**RE: REVISED INTERIM MEASURES WORK PLAN – ENGLEWOOD INTERMODAL YARD
UNION PACIFIC RAILROAD COMPANY – HOUSTON WOOD PRESERVING WORKS
4910 LIBERTY ROAD, HOUSTON, HARRIS COUNTY, TEXAS
HAZARDOUS WASTE PERMIT/COMPLIANCE PLAN NO: 50343, ISWR NO 31547
EPA IDENTIFICATION NO TXD000820266; RN100674613/CN600131098**

WSP USA Inc. (WSP), on behalf of Union Pacific Railroad (UPRR), prepared the attached Revised Interim Measures Work Plan (IMWP) – Englewood Intermodal Yard (EIY) for the UPRR Houston Wood Preserving Works (HWPW) (the Site) in response to the Texas Commission on Environmental Quality (TCEQ) comment letter dated July 5, 2023. The TCEQ letter provided comments on the UPRR *Proposed Interim Measures Work Plan* dated May 17, 2023. Below are responses to the TCEQ comments in a comment-response format.

Revised Interim Measure Work Plan – Englewood Intermodal Yard Houston Wood Preserving Works, Houston, Texas

FIGURE
A-1

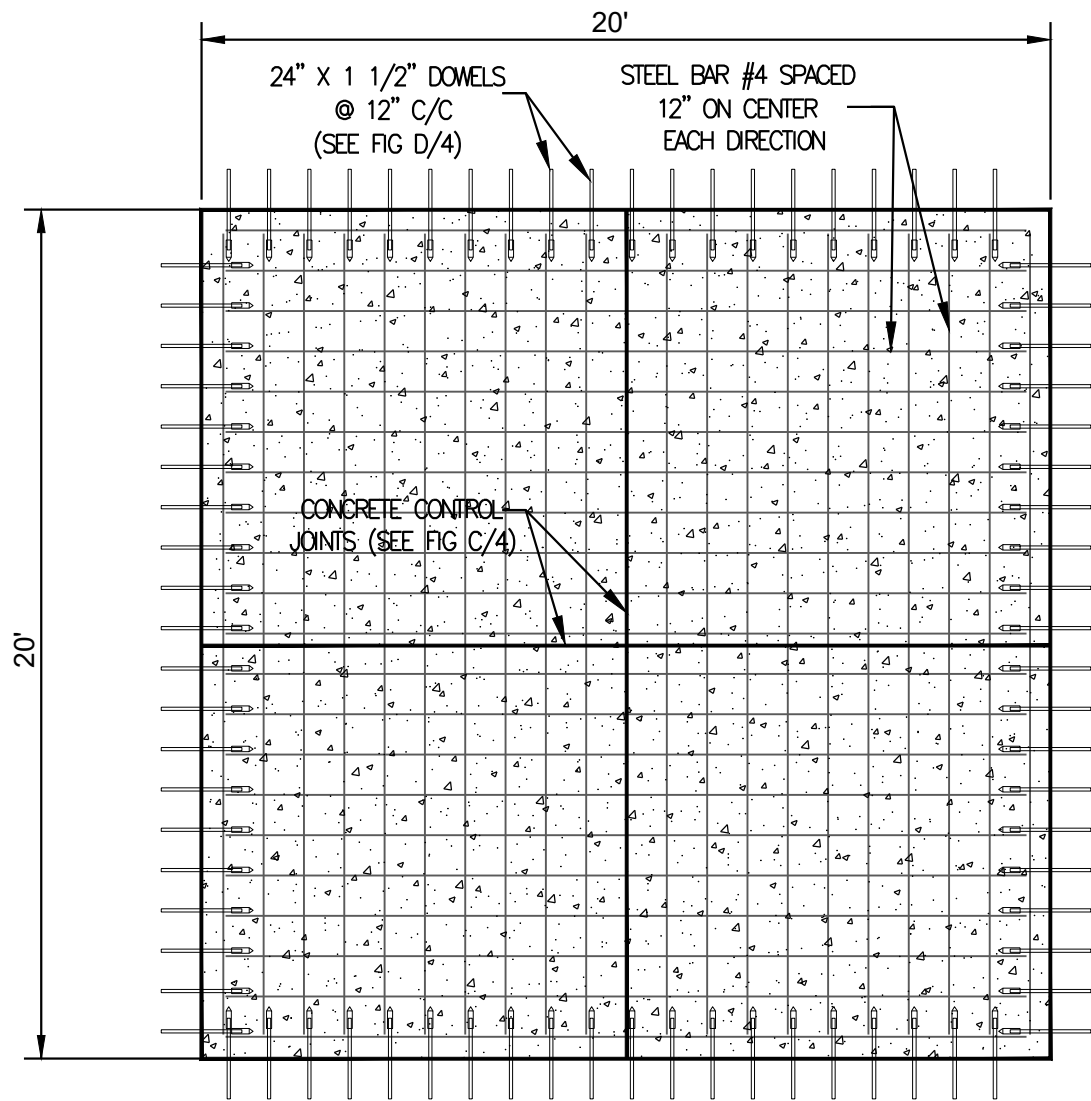
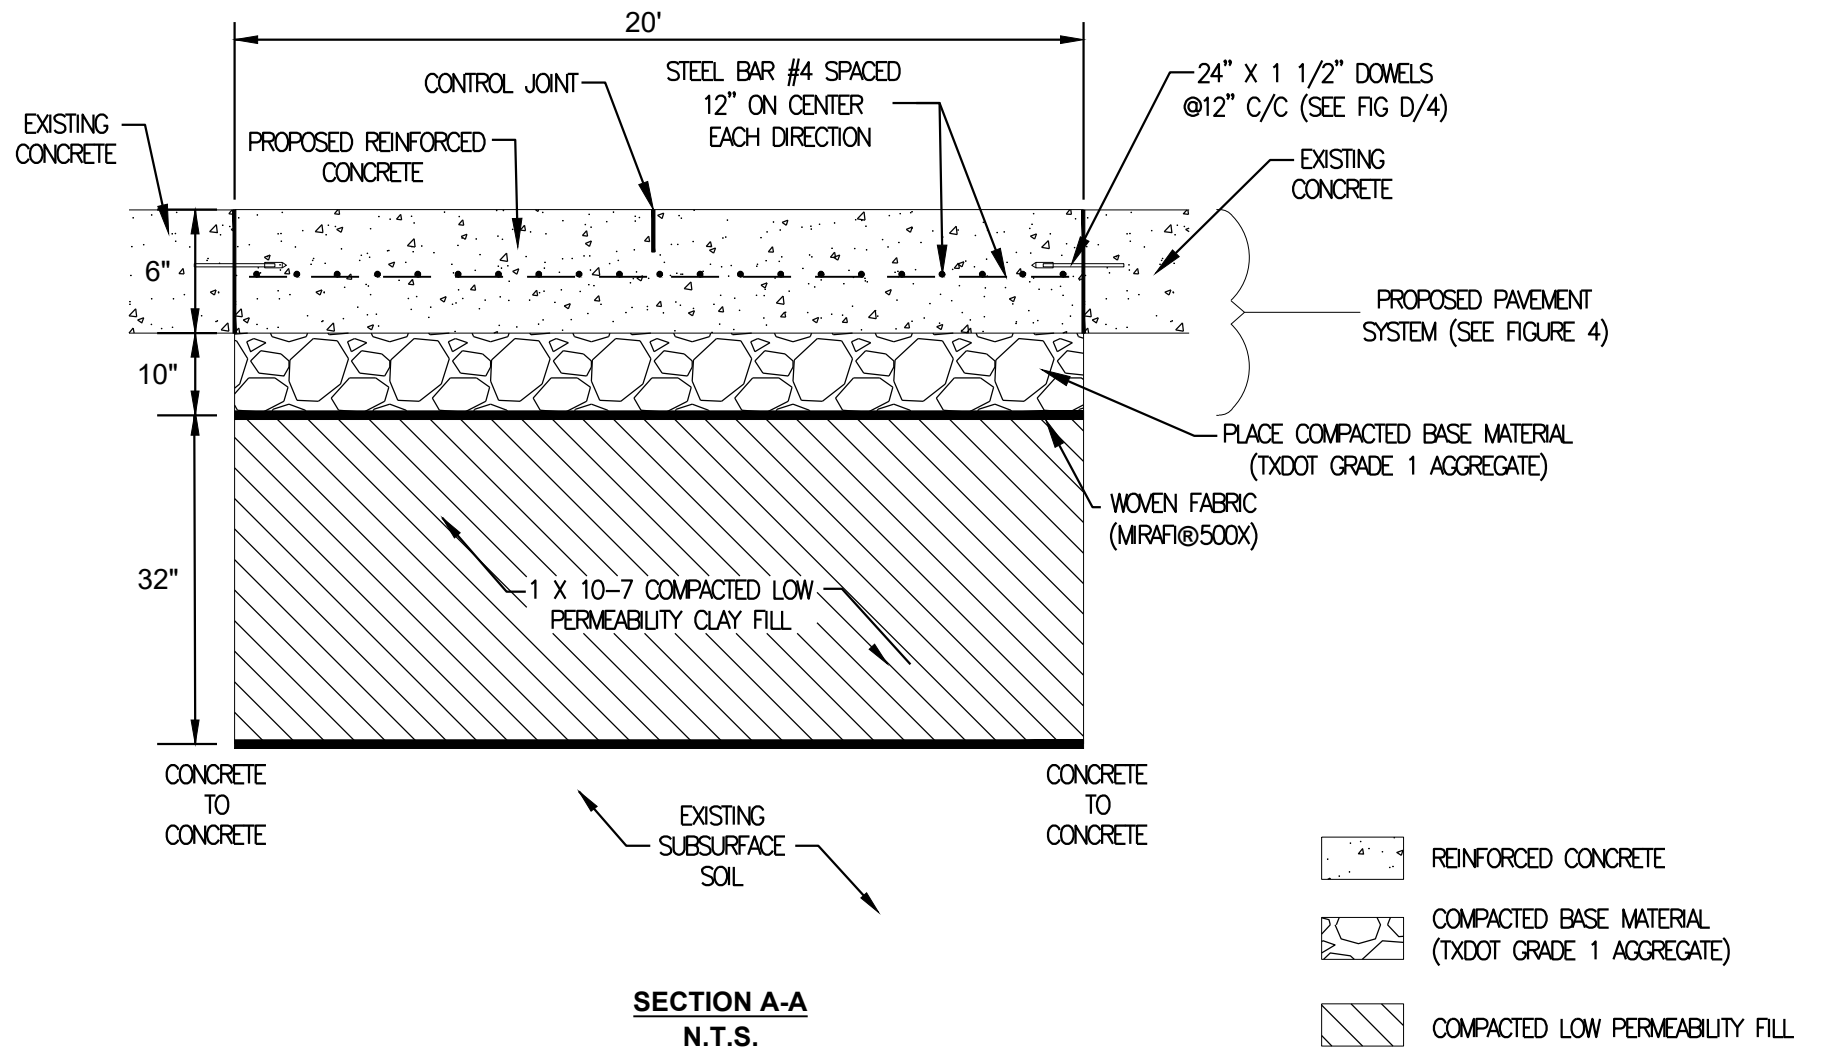
Comment No. 4. The proposed replacement cover for the excavation areas doesn't: (1) provide a demonstration that it is equivalent or better cover than the existing cap (2) prevent cracking of new pavement, and (3) address NAPL seeps through cracks in current cover and any new pavement. Review of the monthly status report and annual post-response action completion report indicates that (1) a tar like material continues to seep through cracks in concrete cap and patched cracked areas, (2) new seeps have been observed in 2022, and (3) overall concrete cap is in poor condition. Therefore, as a part of the interim measure work plan, please assess EIY Cap and propose alternative remedy to address cracks in the cap.

Response: UPRR believes the proposed design in the IMWP of the reinforced concrete cover (6 inches) combined with the underlying base material (10 inches) and compacted clay (approximately 32 inches) is equivalent or better than the existing cap, which does not include the clean, compacted clay (1×10^{-7} cm/sec) layer. The total thickness of the cover following the focused excavation will be four feet compared to the current concrete pavement of six inches with underlying base material (as shown in the photograph at the bottom of page 3 of this letter).

The concrete and base material elements of the design matches the concrete cover that was constructed as part of the NAPL Collection System³, which consisted of 10-inches of compacted base material and 6-inches of reinforced concrete pavement. WSP has conducted weekly inspections of the NAPL Collection System and has not observed any significant cracks in the pavement except along the edges where the new concrete joins with the previous concrete cover. The following photograph taken in May 2023 shows the concrete cover for the NAPL Collection System. There are no significant cracks observed across the NAPL Collection System area except along the joint with the existing concrete (note cracks along joint near "B107" label). A tar-like material seep is noted at the joint between the new concrete and previous concrete cover. It is important to note that the scope for the NAPL Collection System constructed in 2019 did not include over excavating for visually-observed NAPL in the sidewalls of the excavation. The tar-like material seep noted in the following photograph likely is due to a NAPL source below the joint between the new and old concrete cover. The proposed scope provided in the Revised IMWP for the focused excavations includes over excavating the soils where NAPL is visually observed, thereby removing the potential for NAPL seeps to develop at the joints between the new and old concrete cover.
